SUBJECT: **Addendum No. 1**
Caswell Enterprise Center
Yanceyville, NC

FROM: Ramsay Burgin Smith Architects, Inc.
225 North Main Street - Suite 501
Salisbury, NC 28144

ADDENDUM No.1
**BULLETIN
DRAWING**

MAIN STREET
SECTION @ AWNING
ABD1.1 SCALE: N.T.S.

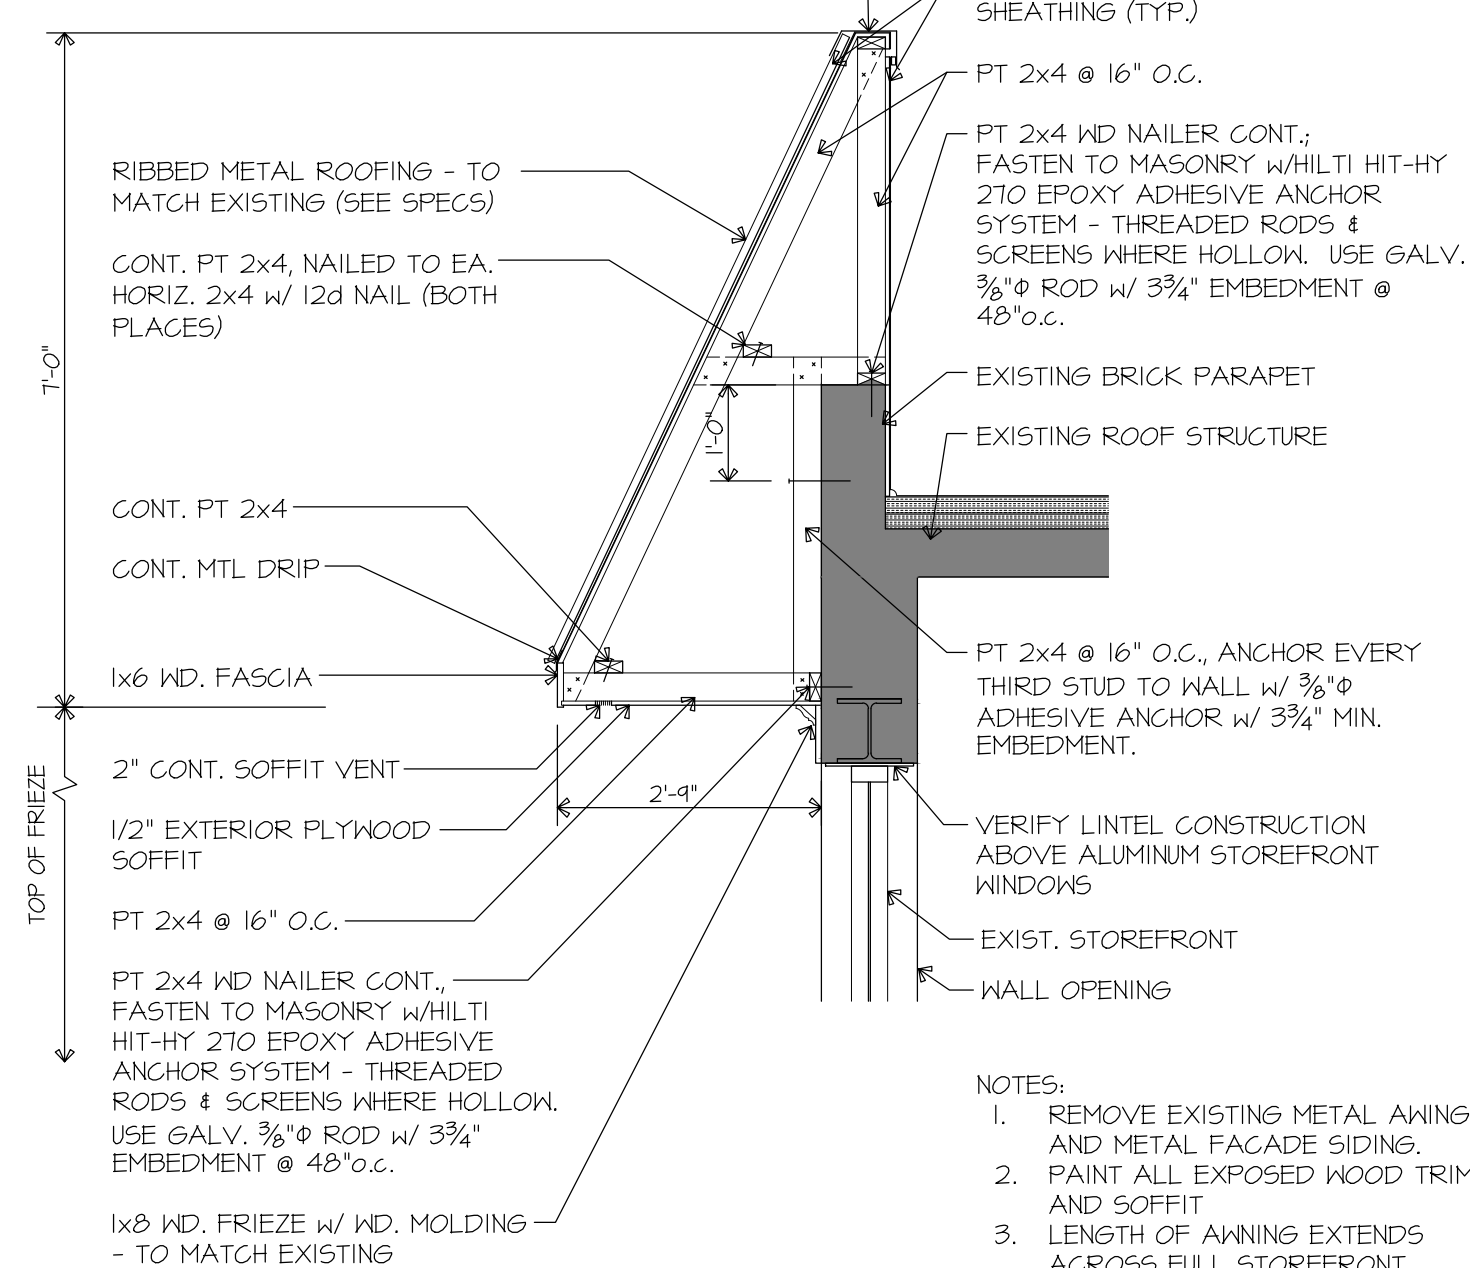
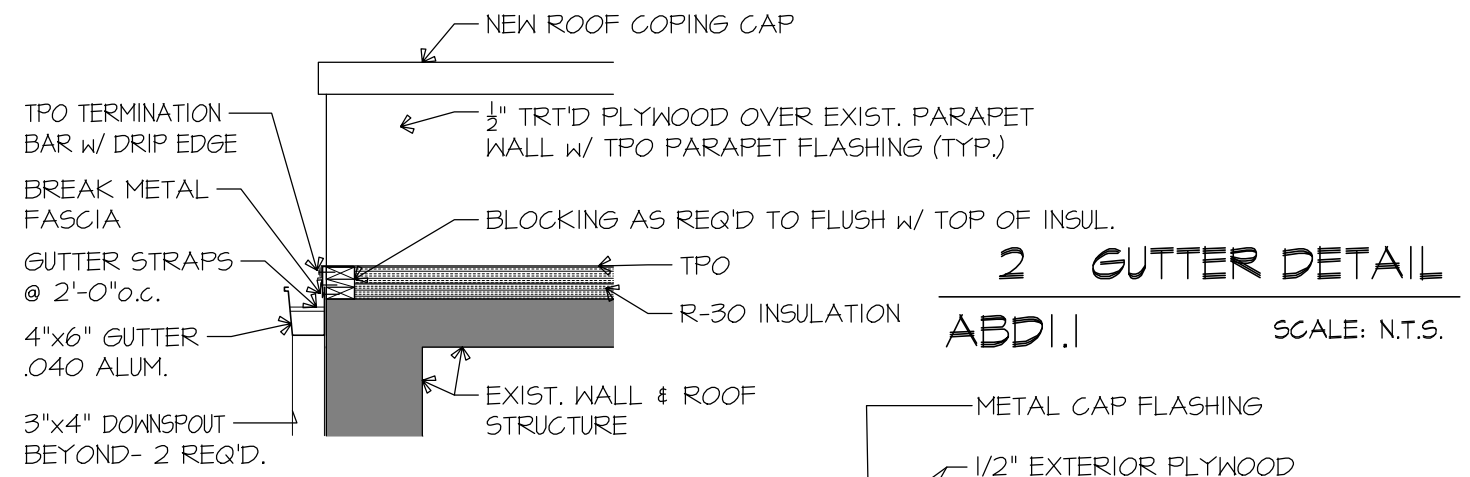
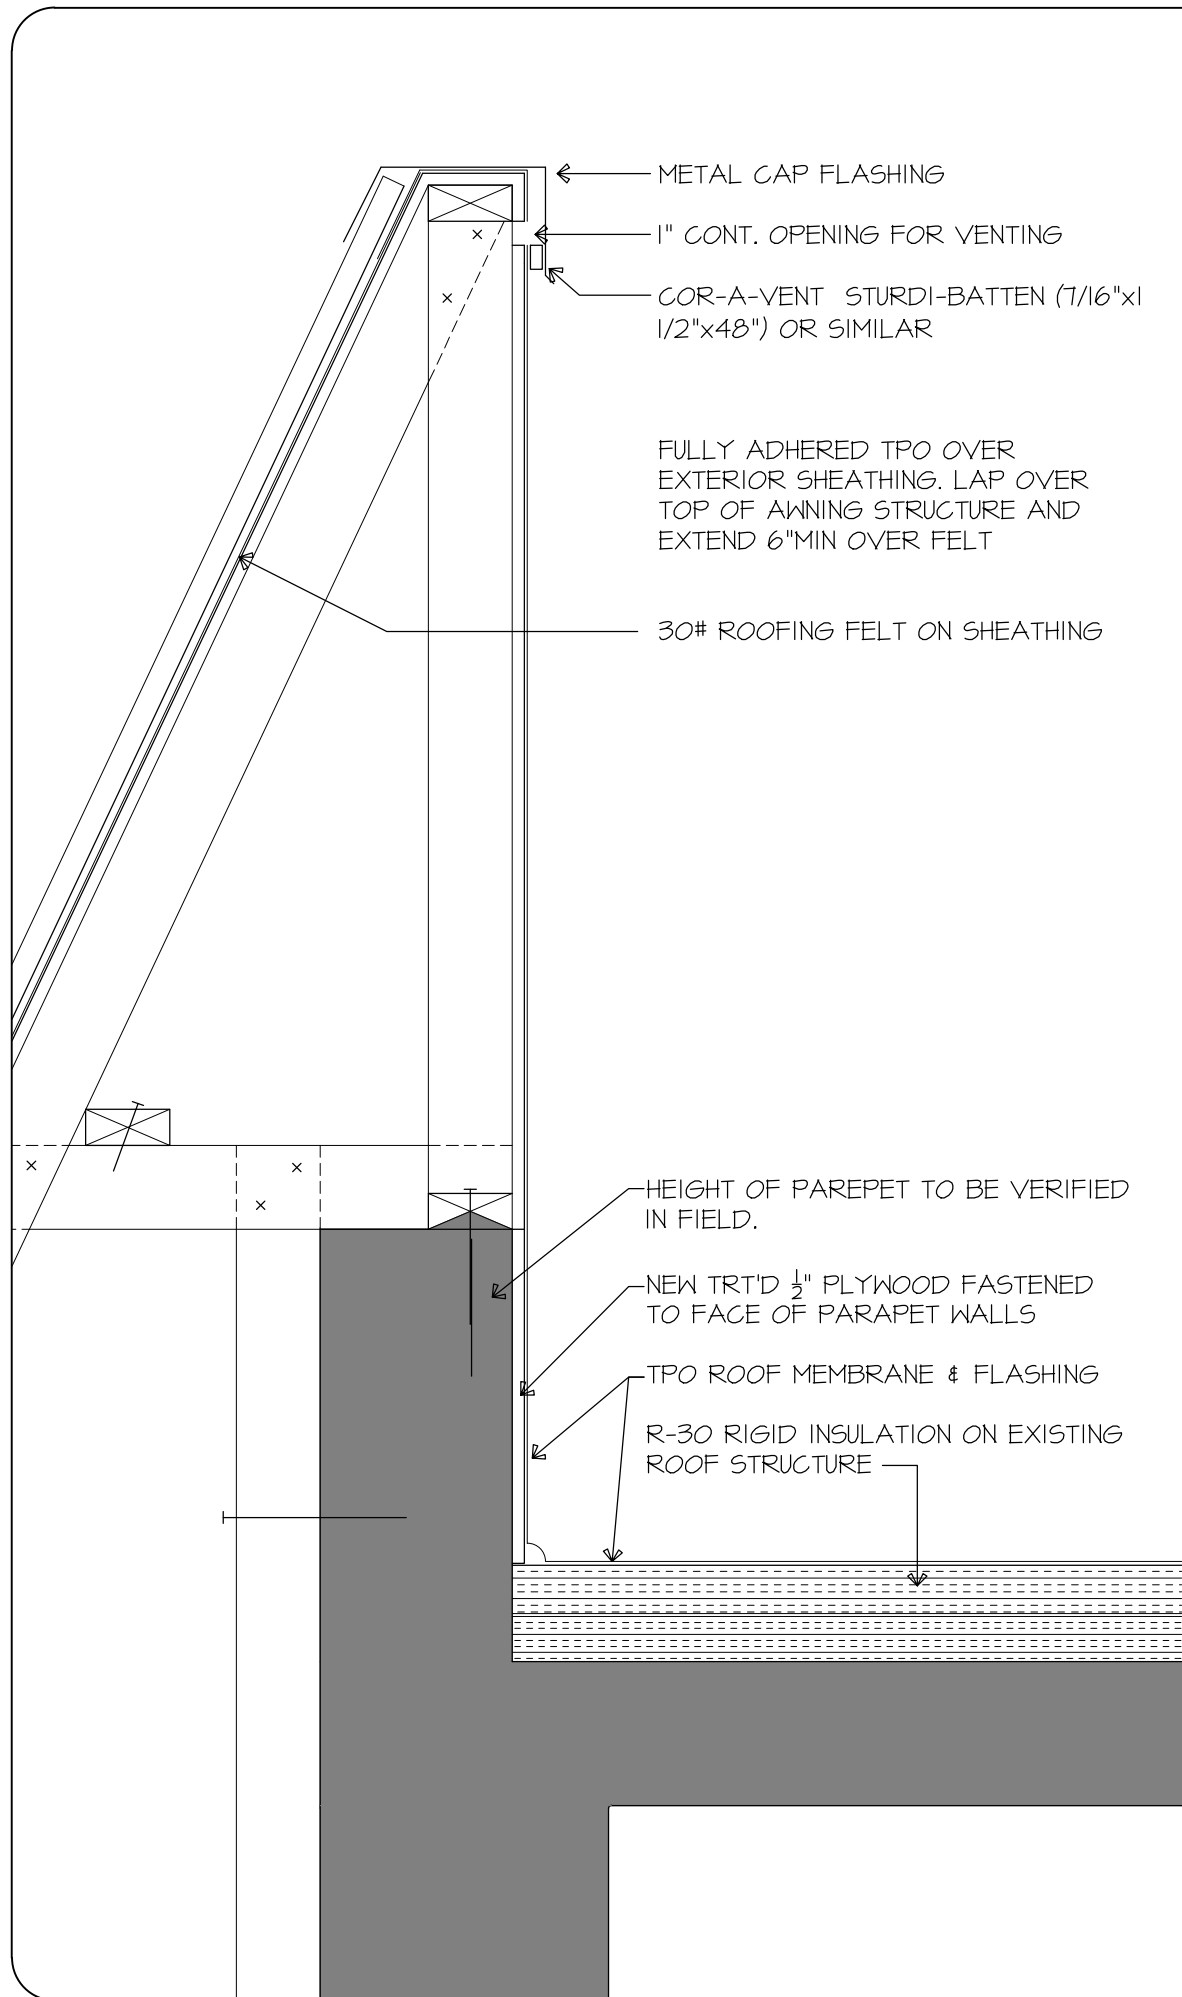
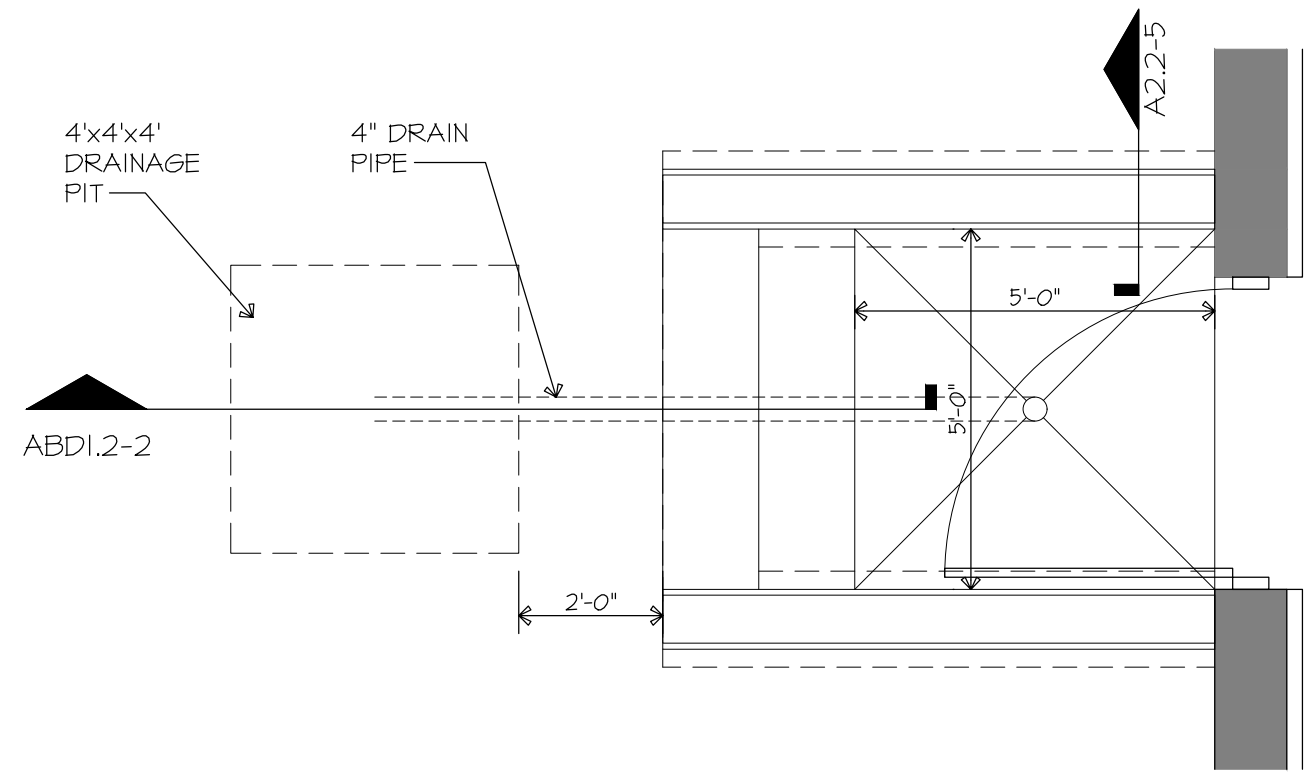
See attached Sheet ABD1.1 Section at New Awning Canopy over the sidewalk entrance of the Retail store opening off of Main Street as shown dashed and noted on the plans.

- NOTES:
1. REMOVE EXISTING METAL AWING AND METAL FACADE SIDING.
 2. PAINT ALL EXPOSED WOOD TRIM AND SOFFIT
 3. LENGTH OF AWNING EXTENDS ACROSS FULL STOREFRONT
 4. PROVIDE CANOPY END PANELS W/ RIBBED METAL SIDING OVER PLYWOOD.

1
ABDI.2 **DRAINAGE PIT/STEP PLAN**
SCALE: 3/8"=1'-0"

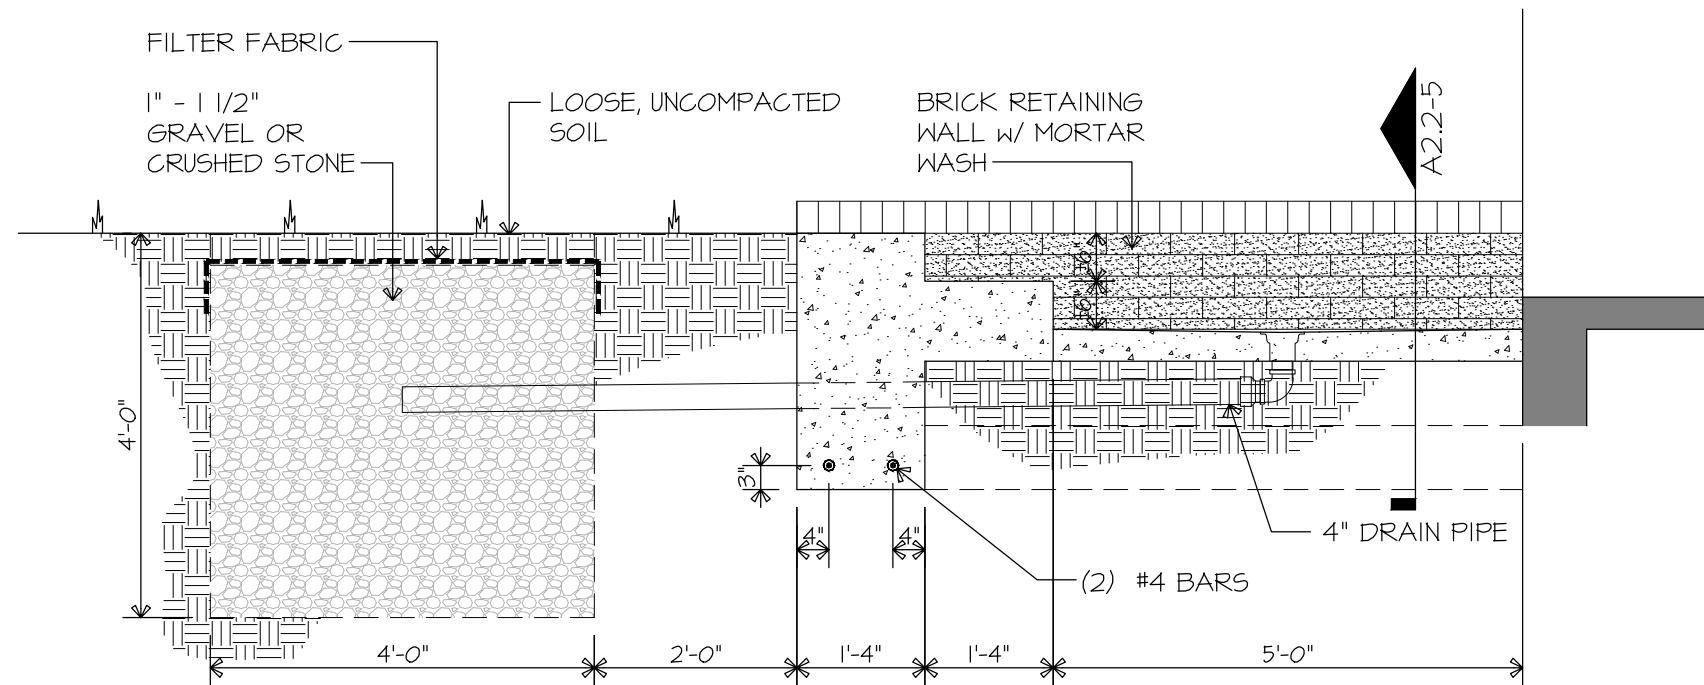
See attached Sheet ADB1.2 Drainage Pit/Step Plan & Section detailing the exit areaway outside of Door 204B onto the rear areaway.

SECTION @ RAMP

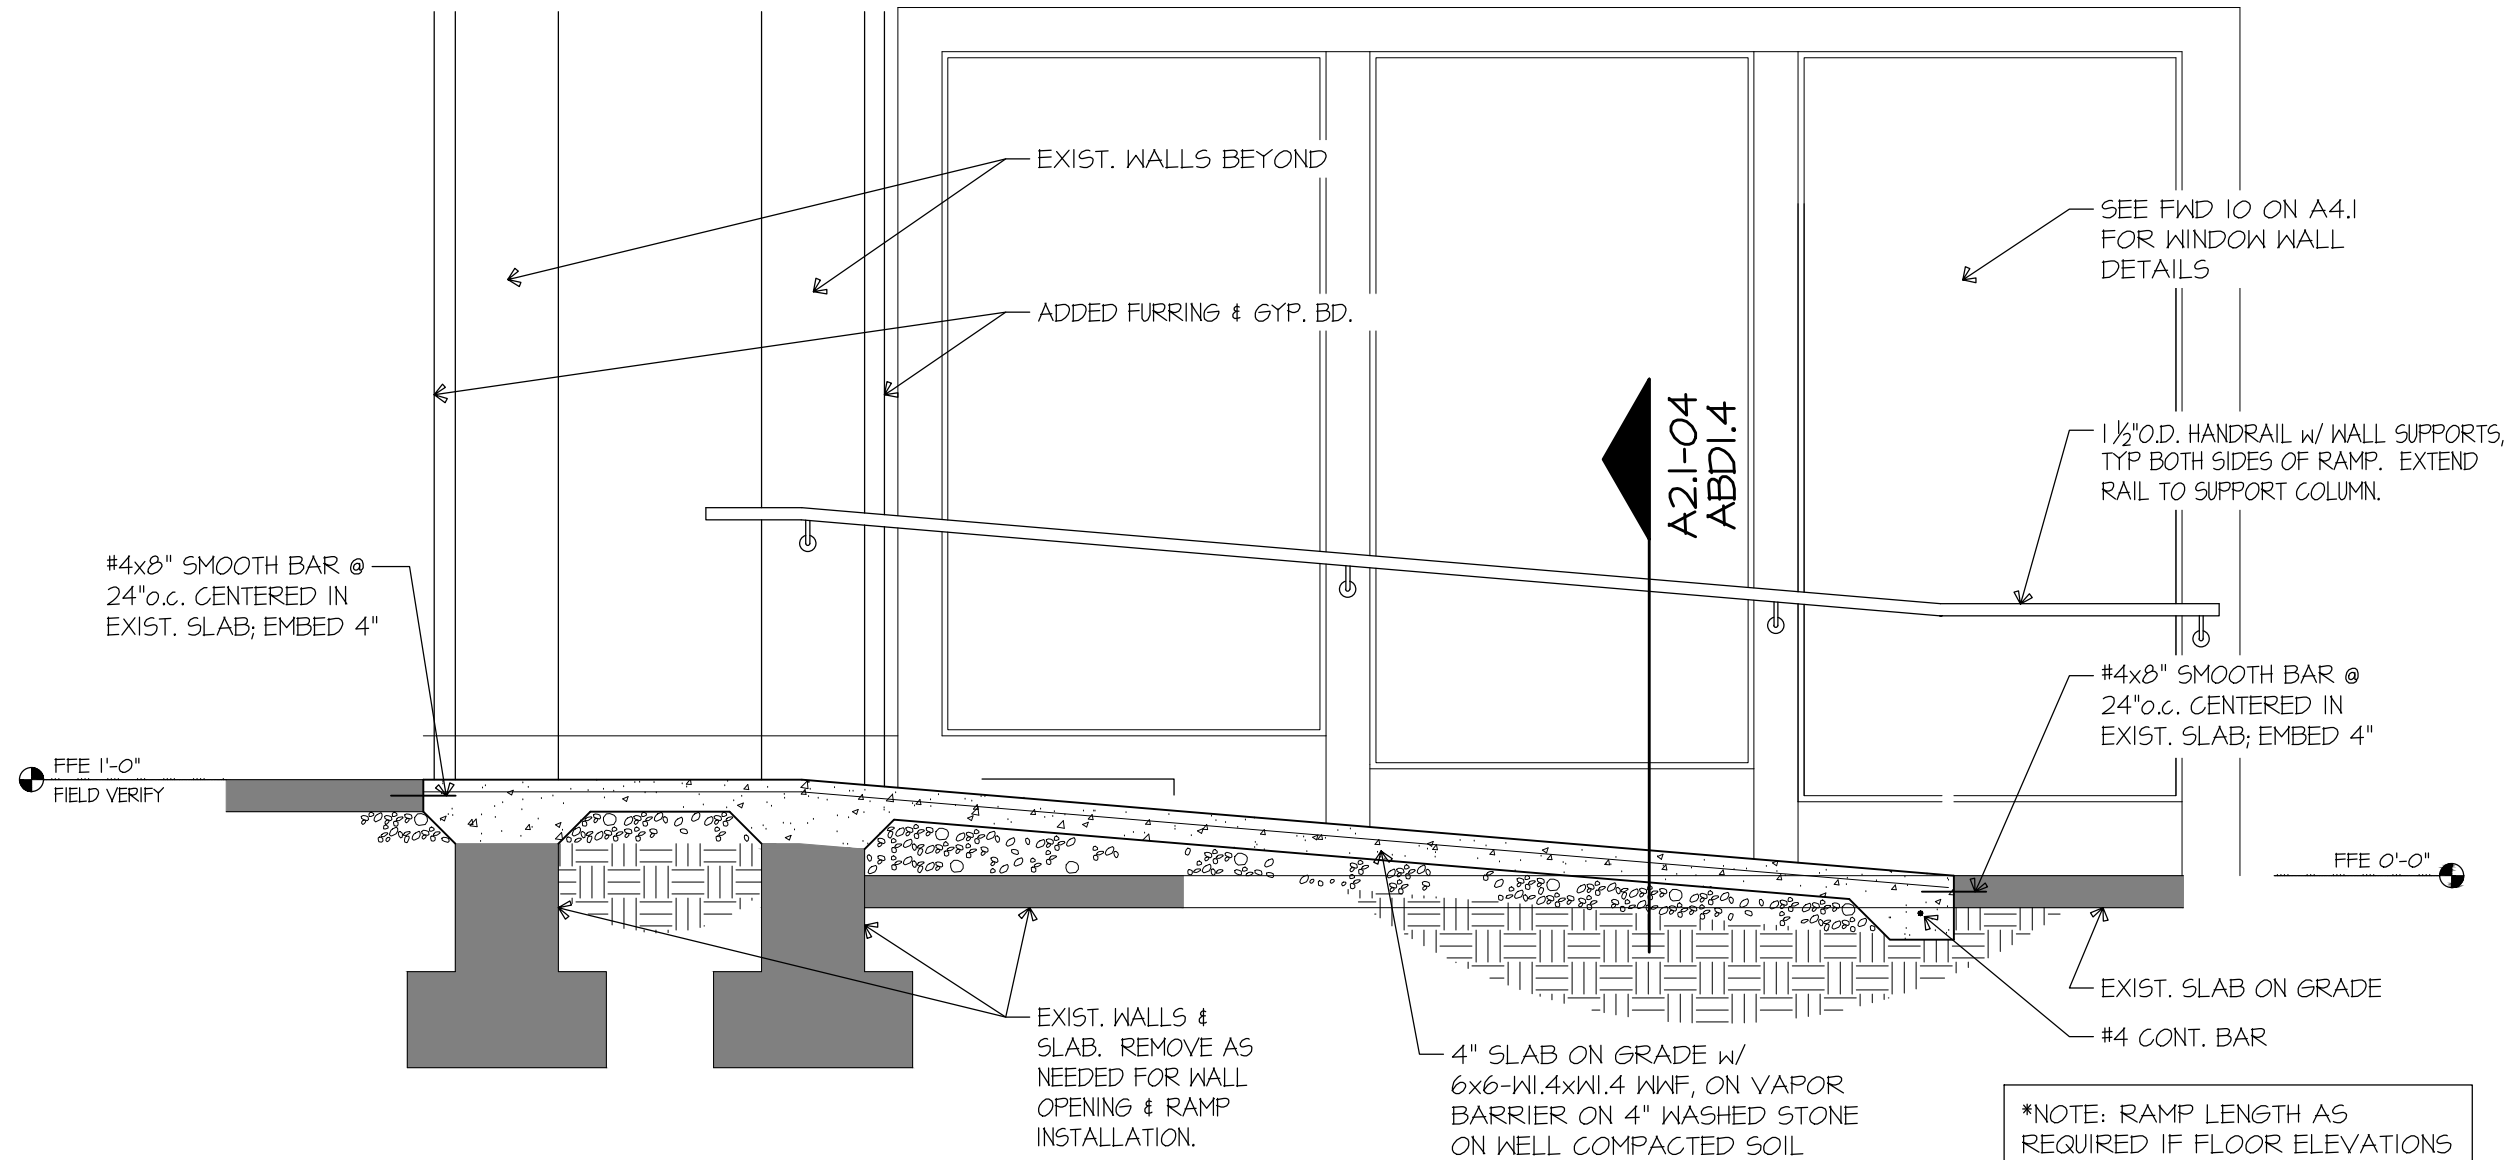
See attached Sheet ABD1.3 Section at Ramp and Sheet ABD1.4 Cross Section at Ramp, that details the new Handicap Accessible ramp configuration between the buildings negotiating the difference between the two finish floor elevations that is thought to be approximately 12”.

*NOTE: RAMP LENGTH AS
REQUIRED IF FLOOR ELEVATIONS
DIFFERENCE IS MORE THAN 12".

*NOTE: THE ADDENDA DRAWING REPLACES THE
LEFT SIDE UP TO THE WALL CORNER OF DETAIL
"FWD 10" W/ A REVISED SECTION OF THIS WALL
INCLUDING THE HC RAIL.
